**ANSTY GARDEN COMMUNITY,**

**DESIGNERS RESPONSE**

**REPORT REF NO. 2207280-R16**

**Road Safety Audit Stage 1**

Client: <b>FAIRFAX ACQUISITIONS LTD</b>			
Project Title: <b>LAND AT ANSTY FARM, MID SUSSEX</b>			
Drawing Title: <b>CYCLE ROUTE IMPROVEMENT PLAN (SHEET 1)</b>			
AO Scale: 1:1000	Date: 07.06.23	Designed by: DV	Drawn by: DV
Checked by: DV	Approved by: DH	Drawing Number: <b>2207280-SK05</b>

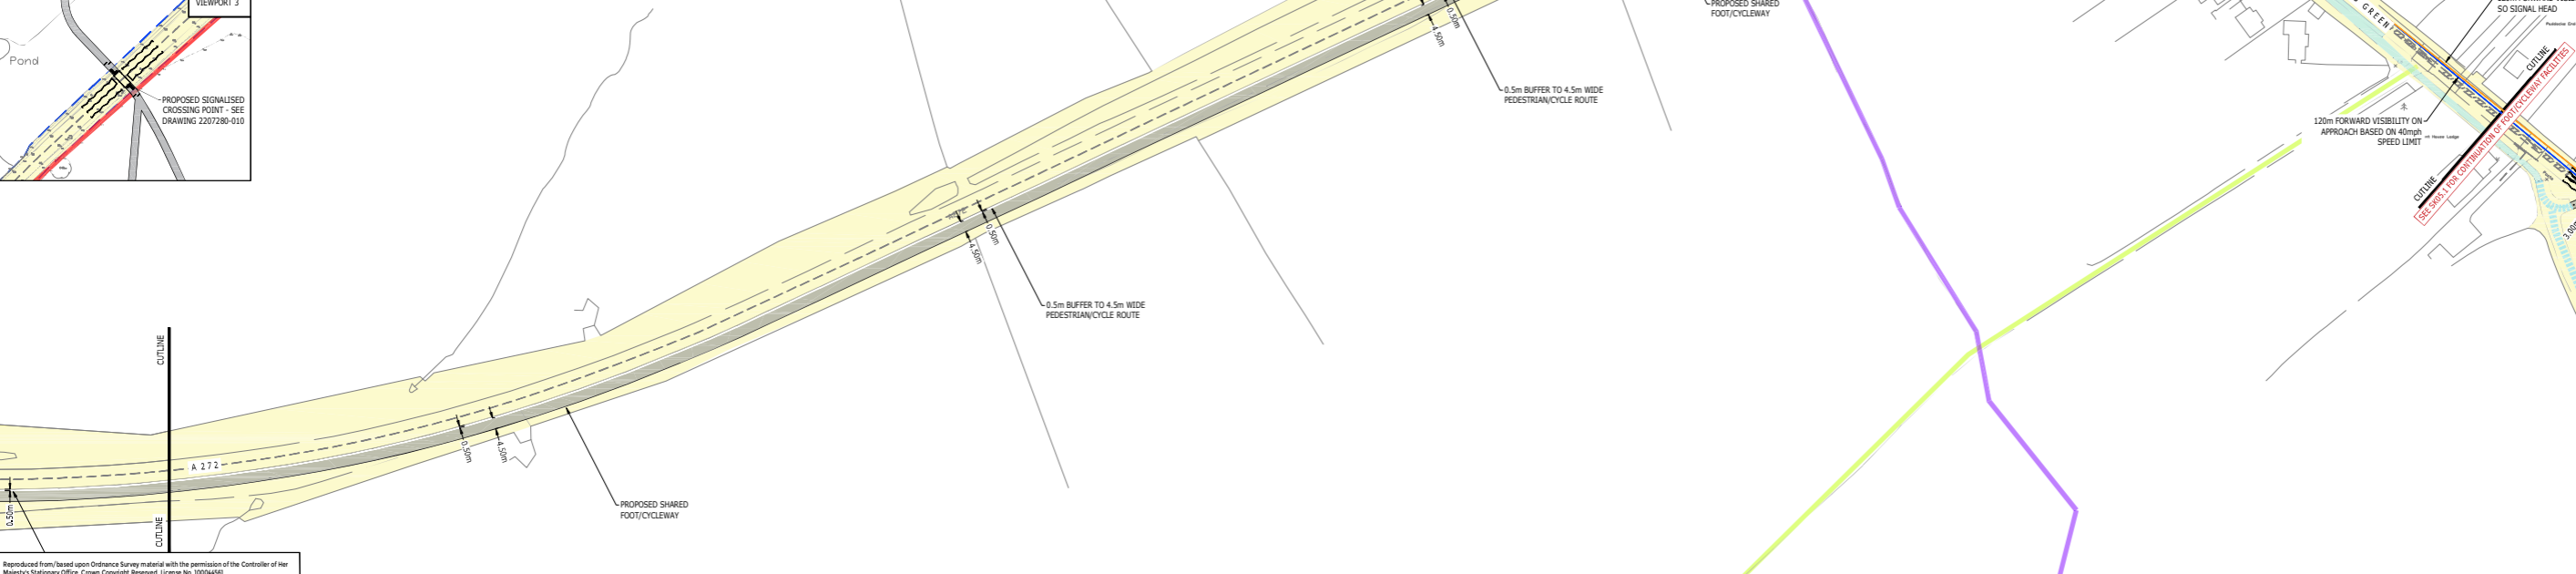
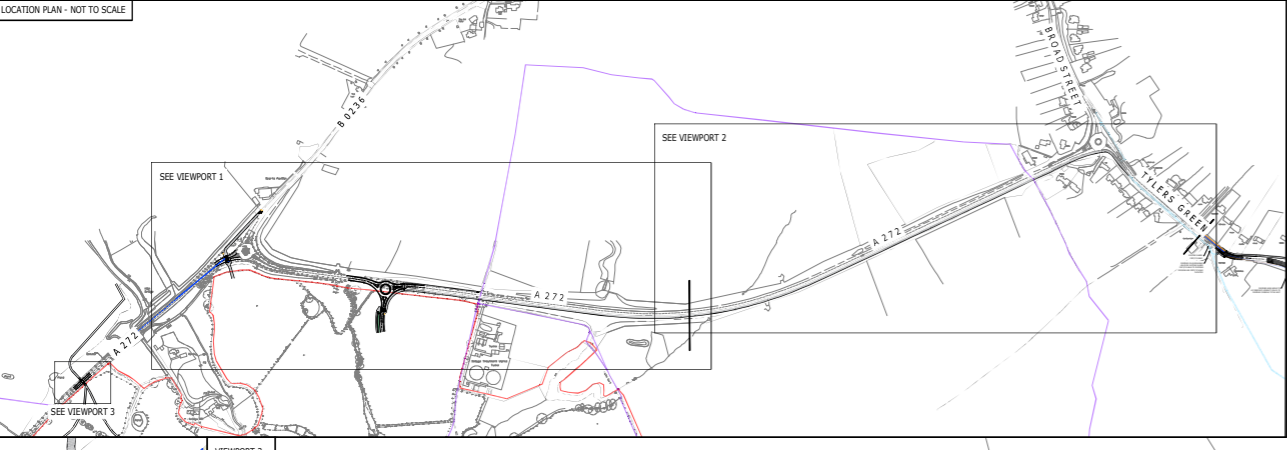
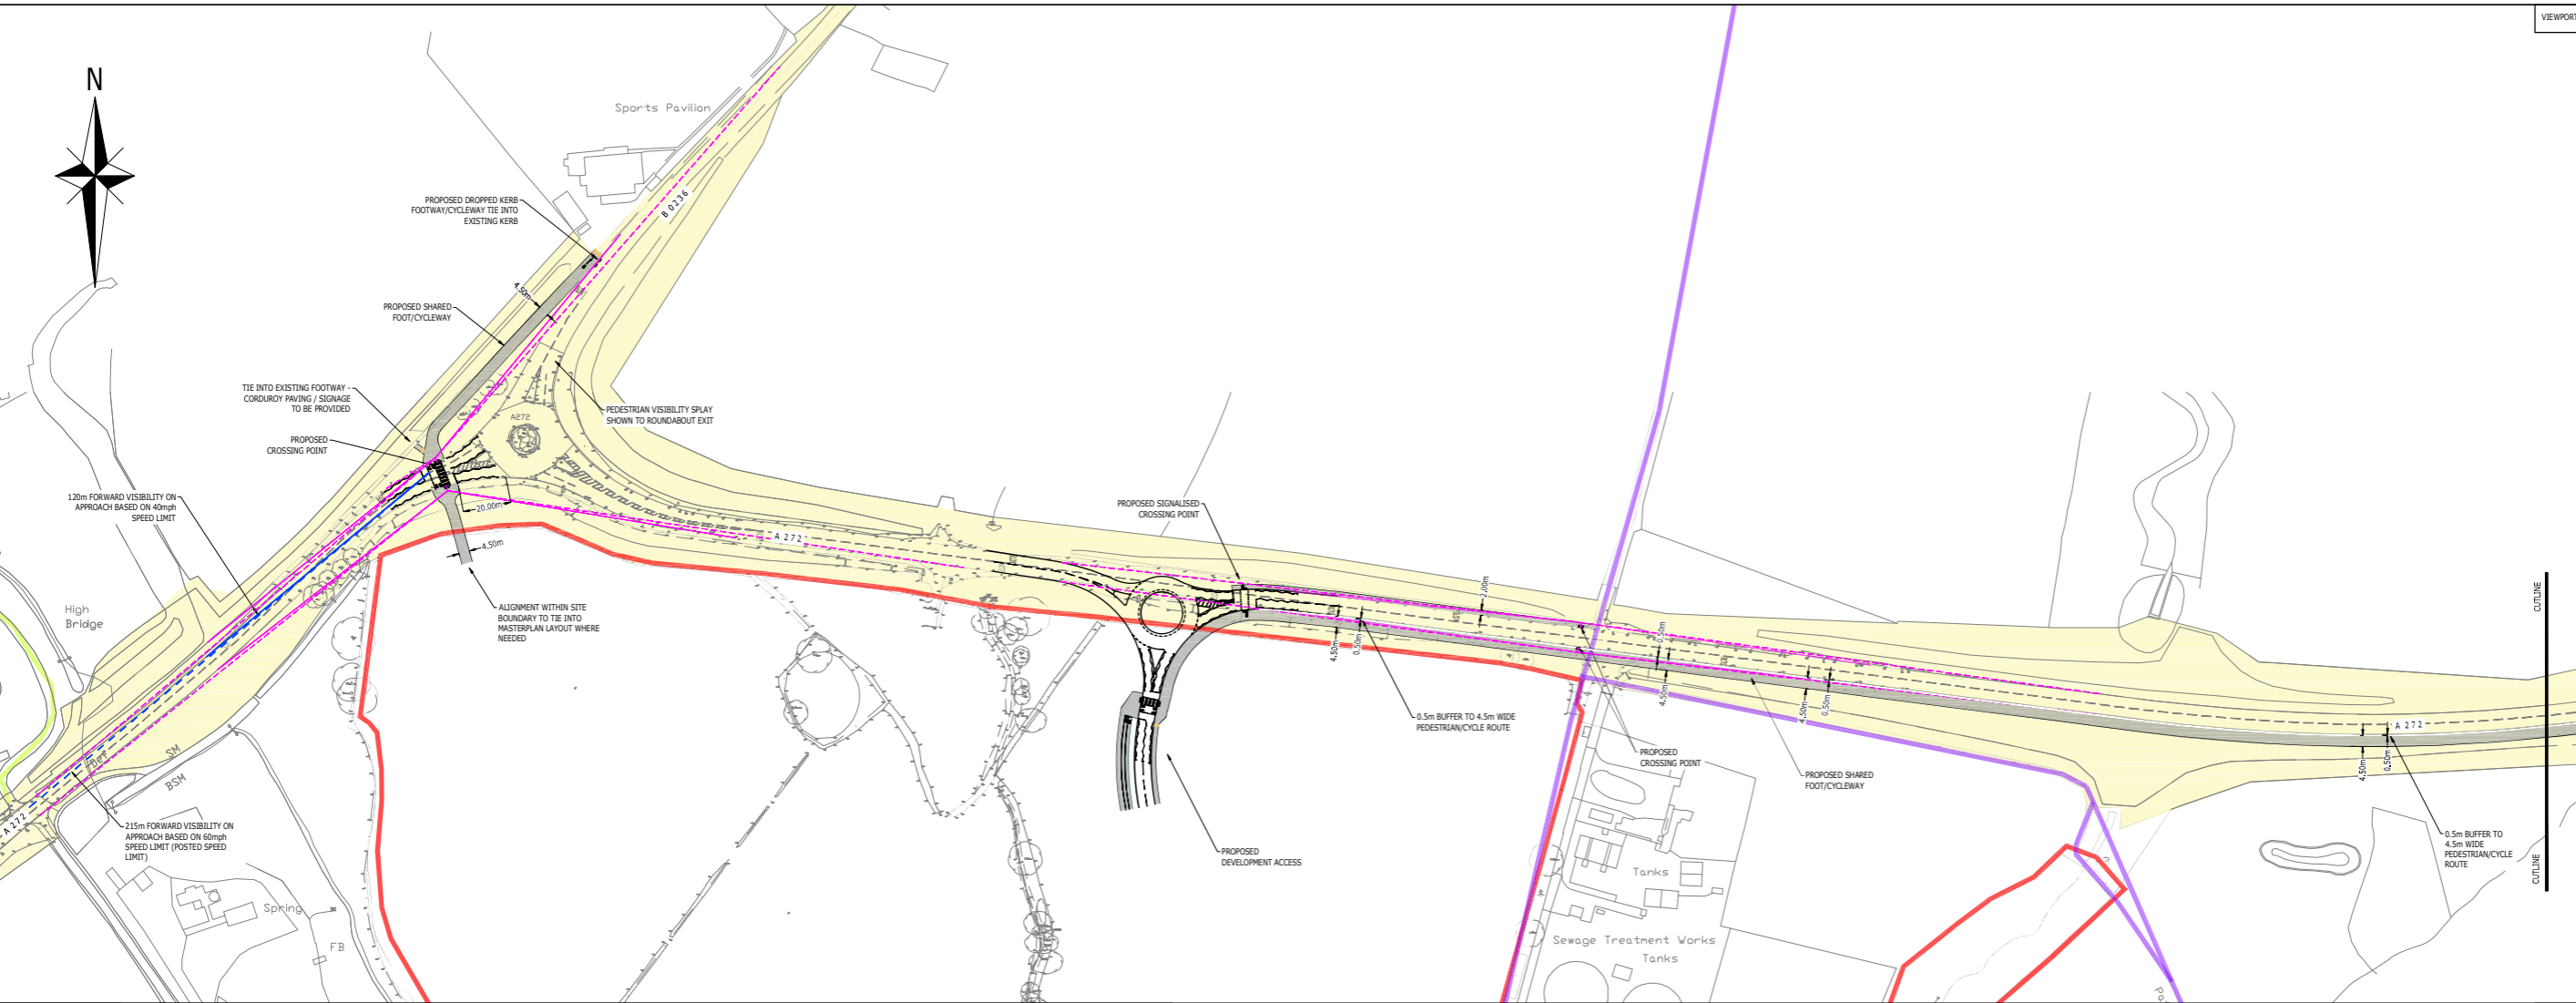
<b>RSA problem</b>	<b>RSA recommendation</b>	<b>Design Organisation response</b>	<b>Overseeing Organisation response</b>	<b>Agreed RSA action</b>
<p>3.1.1 Unlevel footway could lead to cyclist loss of control collisions.</p> <p>The footway on the northern side of the carriageway is proposed to be a shared use footway / cycleway; however, during the site visit it was noted that there was a significant level difference on the existing footway. Such a level difference could increase the risk of cyclist loss of control collisions, particularly during the hours of darkness.</p>	<p>It is recommended that the proposed shared use footway / cycleway should be resurfaced and levelled.</p>	<p>All footway widening works will ensure the levels and gradients are to standards. Details of levels and construction works will be provided for Stage 2 Audit</p>

<p>pedestrian / cyclists collisions.</p>				
<p>3.1.4 Barrier terminal may increase severity of a loss of control collision.</p> <p>To the west of the sewage treatment works on the southern side of the carriageway there is an existing vehicle restraint system (VRS) that lies with the path of the proposed shared use route. Due to the road conditions the Audit Team were unable to determine the terminal type; however, should the VRS have a ramped end P1 terminal, there is concern that if a terminal of this type is reinstated that this could lead to vehicles being launched in the event of a loss of control collision, which could increase severity of the collision. Further, they may be a drop at the rear of the carriageway which may need to be accommodated.</p>	<p>It is recommended that a P4 type terminal should be installed and that the level difference should be accommodated.</p>	<p>Suitable VRS will be incorporated into the works as necessary to accommodate the new pedestrian/cycle facility. Full details to be provided for Stage 2 Safety Audit.</p>

<p>3.1.7 Inappropriate surfacing could lead to vehicle to pedestrian / cyclist collisions or rear end shunts.</p> <p>The proposals do not include the introduction of anti-skid surfacing or a surface with a high polished stone value (PSV) on the approaches to the Parallel crossing. Surfacing with an inadequate PSV could lead to vehicles not being able to stop, leading to possible rear end shunt or vehicle to pedestrian / cyclist collisions.</p>	<p>It is recommended that antiskid surfacing or surfacing with a high PSV should be used on the approaches to the crossings.</p>	<p>Details of PSV values and surfacing materials will be provided for Stage 2 Audit.</p>		
<p>3.1.8 Ponding of surface water could lead to loss of control collisions.</p> <p>Kerblines are being amended as part of these proposals, where no details of carriageway drainage have been provided for assessment; ponding on the carriageway or water moving across the carriageway at junctions or bends could lead to loss of control collisions, particularly in wet / icy conditions.</p>	<p>It is recommended that drainage details should be provided at Stage 2 Safety Audit.</p>	<p>Drainage details will be provided for Stage 2 Safety Audit.</p>

<p>3.1.9 Inappropriate surface material could lead to loss of control collisions.</p> <p>No construction details have been submitted for assessment. Surfacing with an insufficient polished stone value (PSV), PSV could lead to cyclist loss of control collisions in the event of sudden braking manoeuvres.</p>	<p>It is recommended that the PSV of the cycleway surface material should be a minimum of 50PSV.</p>	<p>Details of PSV values and surfacing materials will be provided for Stage 2 Audit.</p>		
<p>3.1.10 Type of kerb may increase the risk of collision involving an errant vehicle and pedestrian or cyclist.</p> <p>Observations on site indicated that the existing kerbs are a 45-degree splayed type, where new sections of footway/cycleway are proposed. The splay type kerb decreases the vehicle containment risk of the kerb, allowing easier footway overrun for vehicles. This may increase the risk of pedestrians or cyclists being hit by vehicles in the event that a vehicle loses control.</p>	<p>It is recommended that kerbing at new sections of footway / cycleway should be of half batter type</p>	<p>New sections of foot/cycleway will be proposed in accordance with WSCC design requirements. Details of kerbing will be provided for Stage 2 Safety Audit.</p>

<p>3.4.5 Existing street furniture and trees could lead to cyclist loss of control collisions.</p> <p>A shared use footway / cycleway is proposed. There is existing street furniture, vegetation and trees along the route that lies within the proposed shared route, whose presence may reduce the effective width of the footway. This could lead to cyclists colliding with street furniture or trees, leading to cyclists' loss of control collisions.</p>	<p>It is recommended that street furniture is located to the rear of the footway, that tree canopies and vegetation should be cut back and that matures trees should have a reflective banding.</p>	<p>It has been noted on <b>ACE Drawings 2207280-SK05B / SK05.1B</b> that all street furniture is to be relocated to the back of any proposed footway widening. Also noted on the drawing is that all vegetation / trees should be cut back and mature trees to have reflective banding.</p>

VEGETATION WITHIN VISIBILITY SPLAYS TO BE TRIMMED AND CUT BACK TO KEEP VISIBILITY SPLAYS CLEAR. MATURE TREES TO HAVE REFLECTIVE BANDING.

ANY STREET FURNITURE TO BE RELOCATED IS TO BE POSITIONED TO THE BACK OF THE FOOT/CYCLEWAY.

Drawing Number: **2207280-SK05.1** Rev: **B**

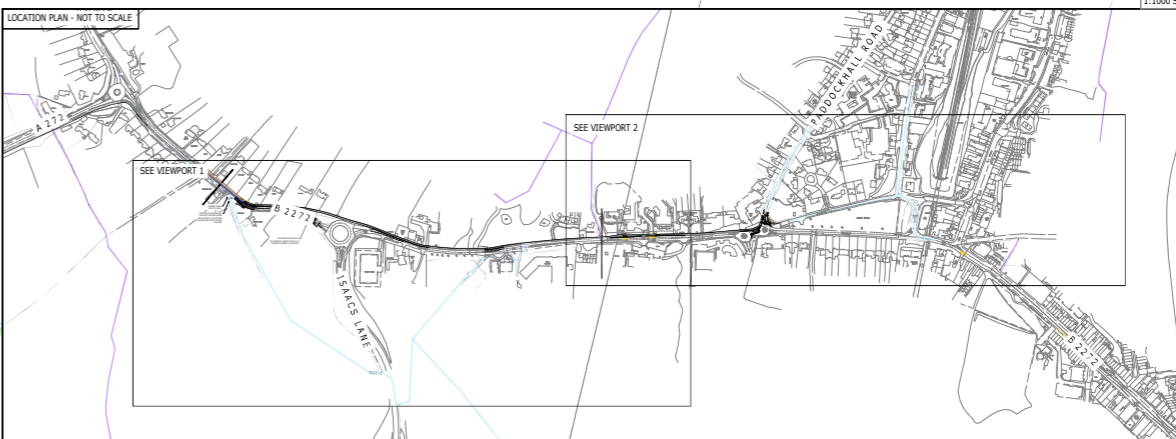
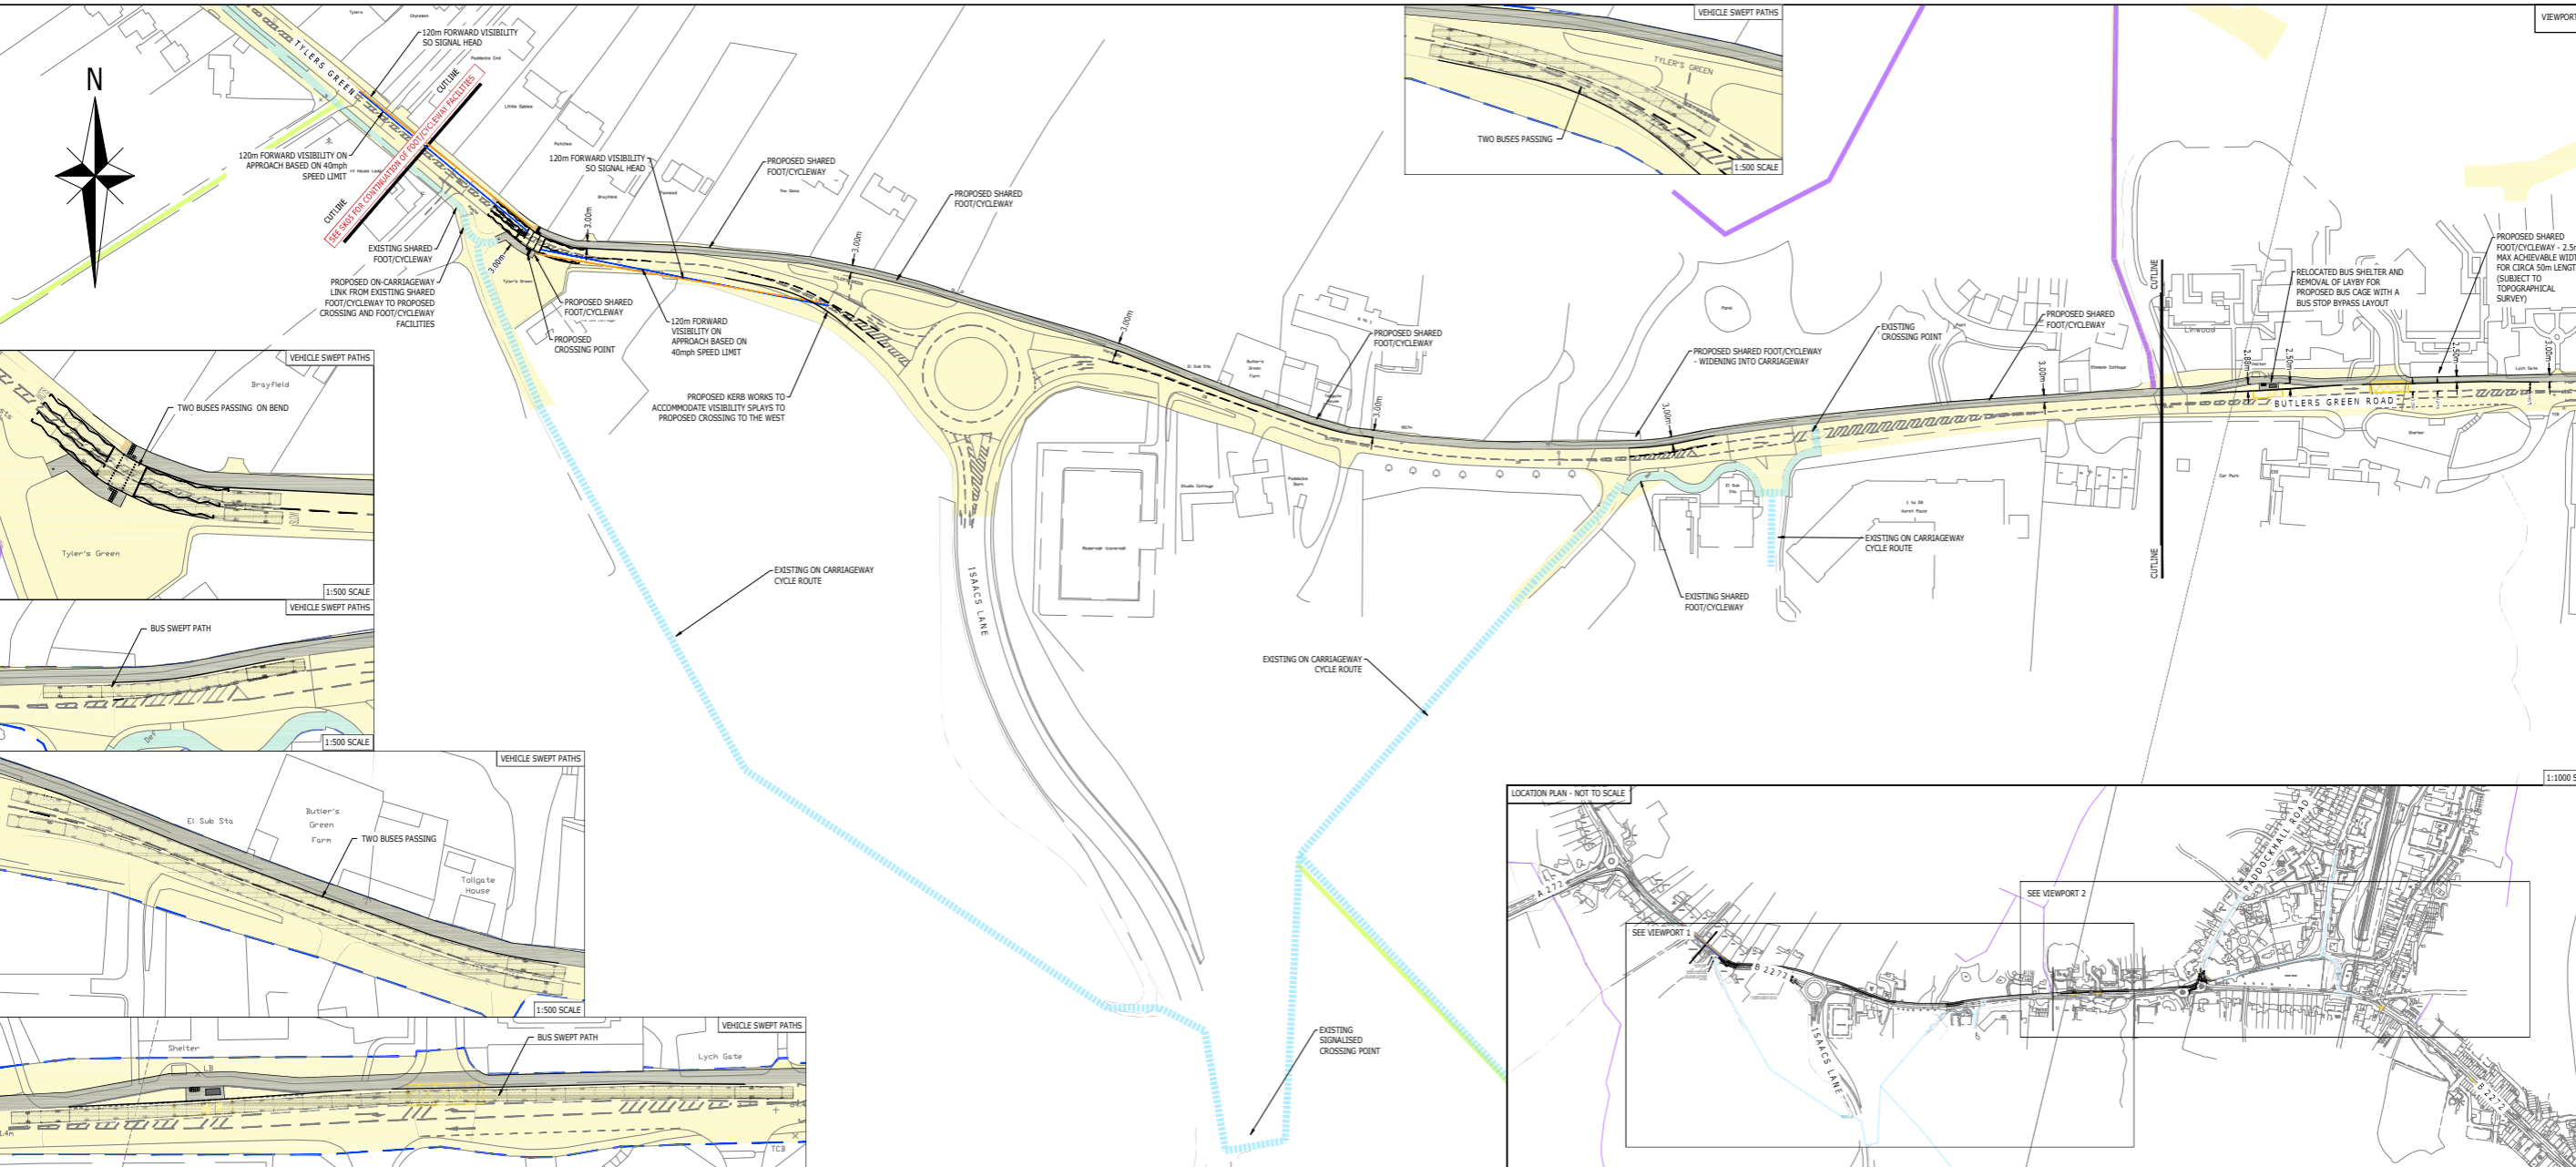
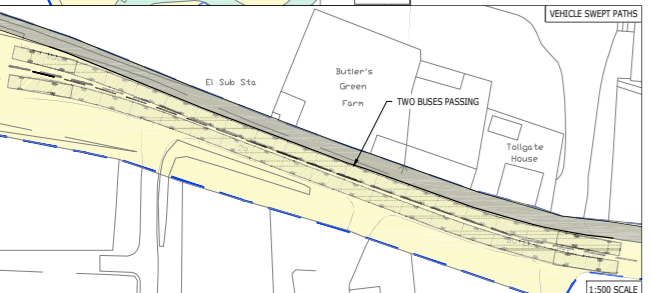
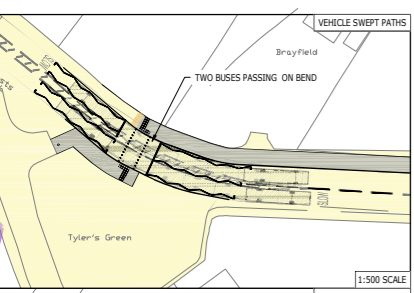
<p>3.1.3 High approach speeds could lead to vehicle to pedestrian / cyclists collisions.</p> <p>Although on site observed traffic speeds were moderate, no traffic flow, speed data or details of pedestrian movements were supplied for assessment, where a 40mph speed limit applies to the section of the A272. Parallel crossings should not be installed on roads where the 85th percentile speed is above 35mph, as otherwise this may lead to vehicle to</p>	<p>It is recommended that details of traffic speeds should be provided for assessment. If the 85th percentile speed is above 35mph then an alternative crossing type should be installed, or that speed reduction measures should be employed in advance of the crossing.</p>	<p>The crossing has been amended to a toucan crossing as shown on <b>ACE Drawing 2207280-SK05.1B</b>.</p>

<p>3.2.2 Insufficient Stopping Sight Distance could lead to vehicle to pedestrian / cyclist collisions or rear end shunts.</p> <p>Stopping Sight Distances (SSD) have been provided for assessment at 40m eastbound and 94m westbound, where a 40mph speed limit applies to this section of 40mph. There is concern that the eastbound 40m SSD may be insufficient.</p>	<p>It is recommended that the SSD should be recalculated based on the 85th speed and provided for assessment.</p>	<p>The crossing has been amended to a toucan crossing as shown on <b>ACE Drawing 2207280-SK05.1B</b>. Suitable visibility splays can be achieved as shown.</p>

<p>3.4.3 Restricted visibility could lead to vehicle to pedestrian collisions.</p> <p>Details relating to the pedestrian / traffic intervisibility splays at the crossing have been provided for assessment. However, there is concern that vegetation / hedgerow may restrict intervisibility. Restricted intervisibility could lead to vehicle to pedestrian collisions.</p>	<p>It is recommended that the hedgerow should be cut back and periodically maintained to retain visibility.</p>	<p>It has been noted on <b>ACE Drawings 2207280-SK05B / SK05.1B</b> that all hedgerow and vegetation within visibility splays to be cut back and kept clear.</p>		
<p>3.4.4 High speed road and lack of buffer zone could lead to vehicle to cyclist collisions.</p> <p>Whilst the width of the proposed shared use footway / cycleway has been specified, no buffer is proposed. There is concern that without a buffer between the high-speed roads and the shared use route, cyclists may be intimidated and may be susceptible to being struck by passing vehicles.</p>	<p>It is recommended that a buffer of a minimum 0.5m should be applied between the shared use route and the high-speed roads.</p>	<p>In accordance with your recommendation, we have incorporated a 0.5m buffer from the edge of carriageway and offset the route itself to retain a 4.5m wide new facility as shown on <b>ACE Drawings 2207280-SK05B / SK05.1B</b>.</p>
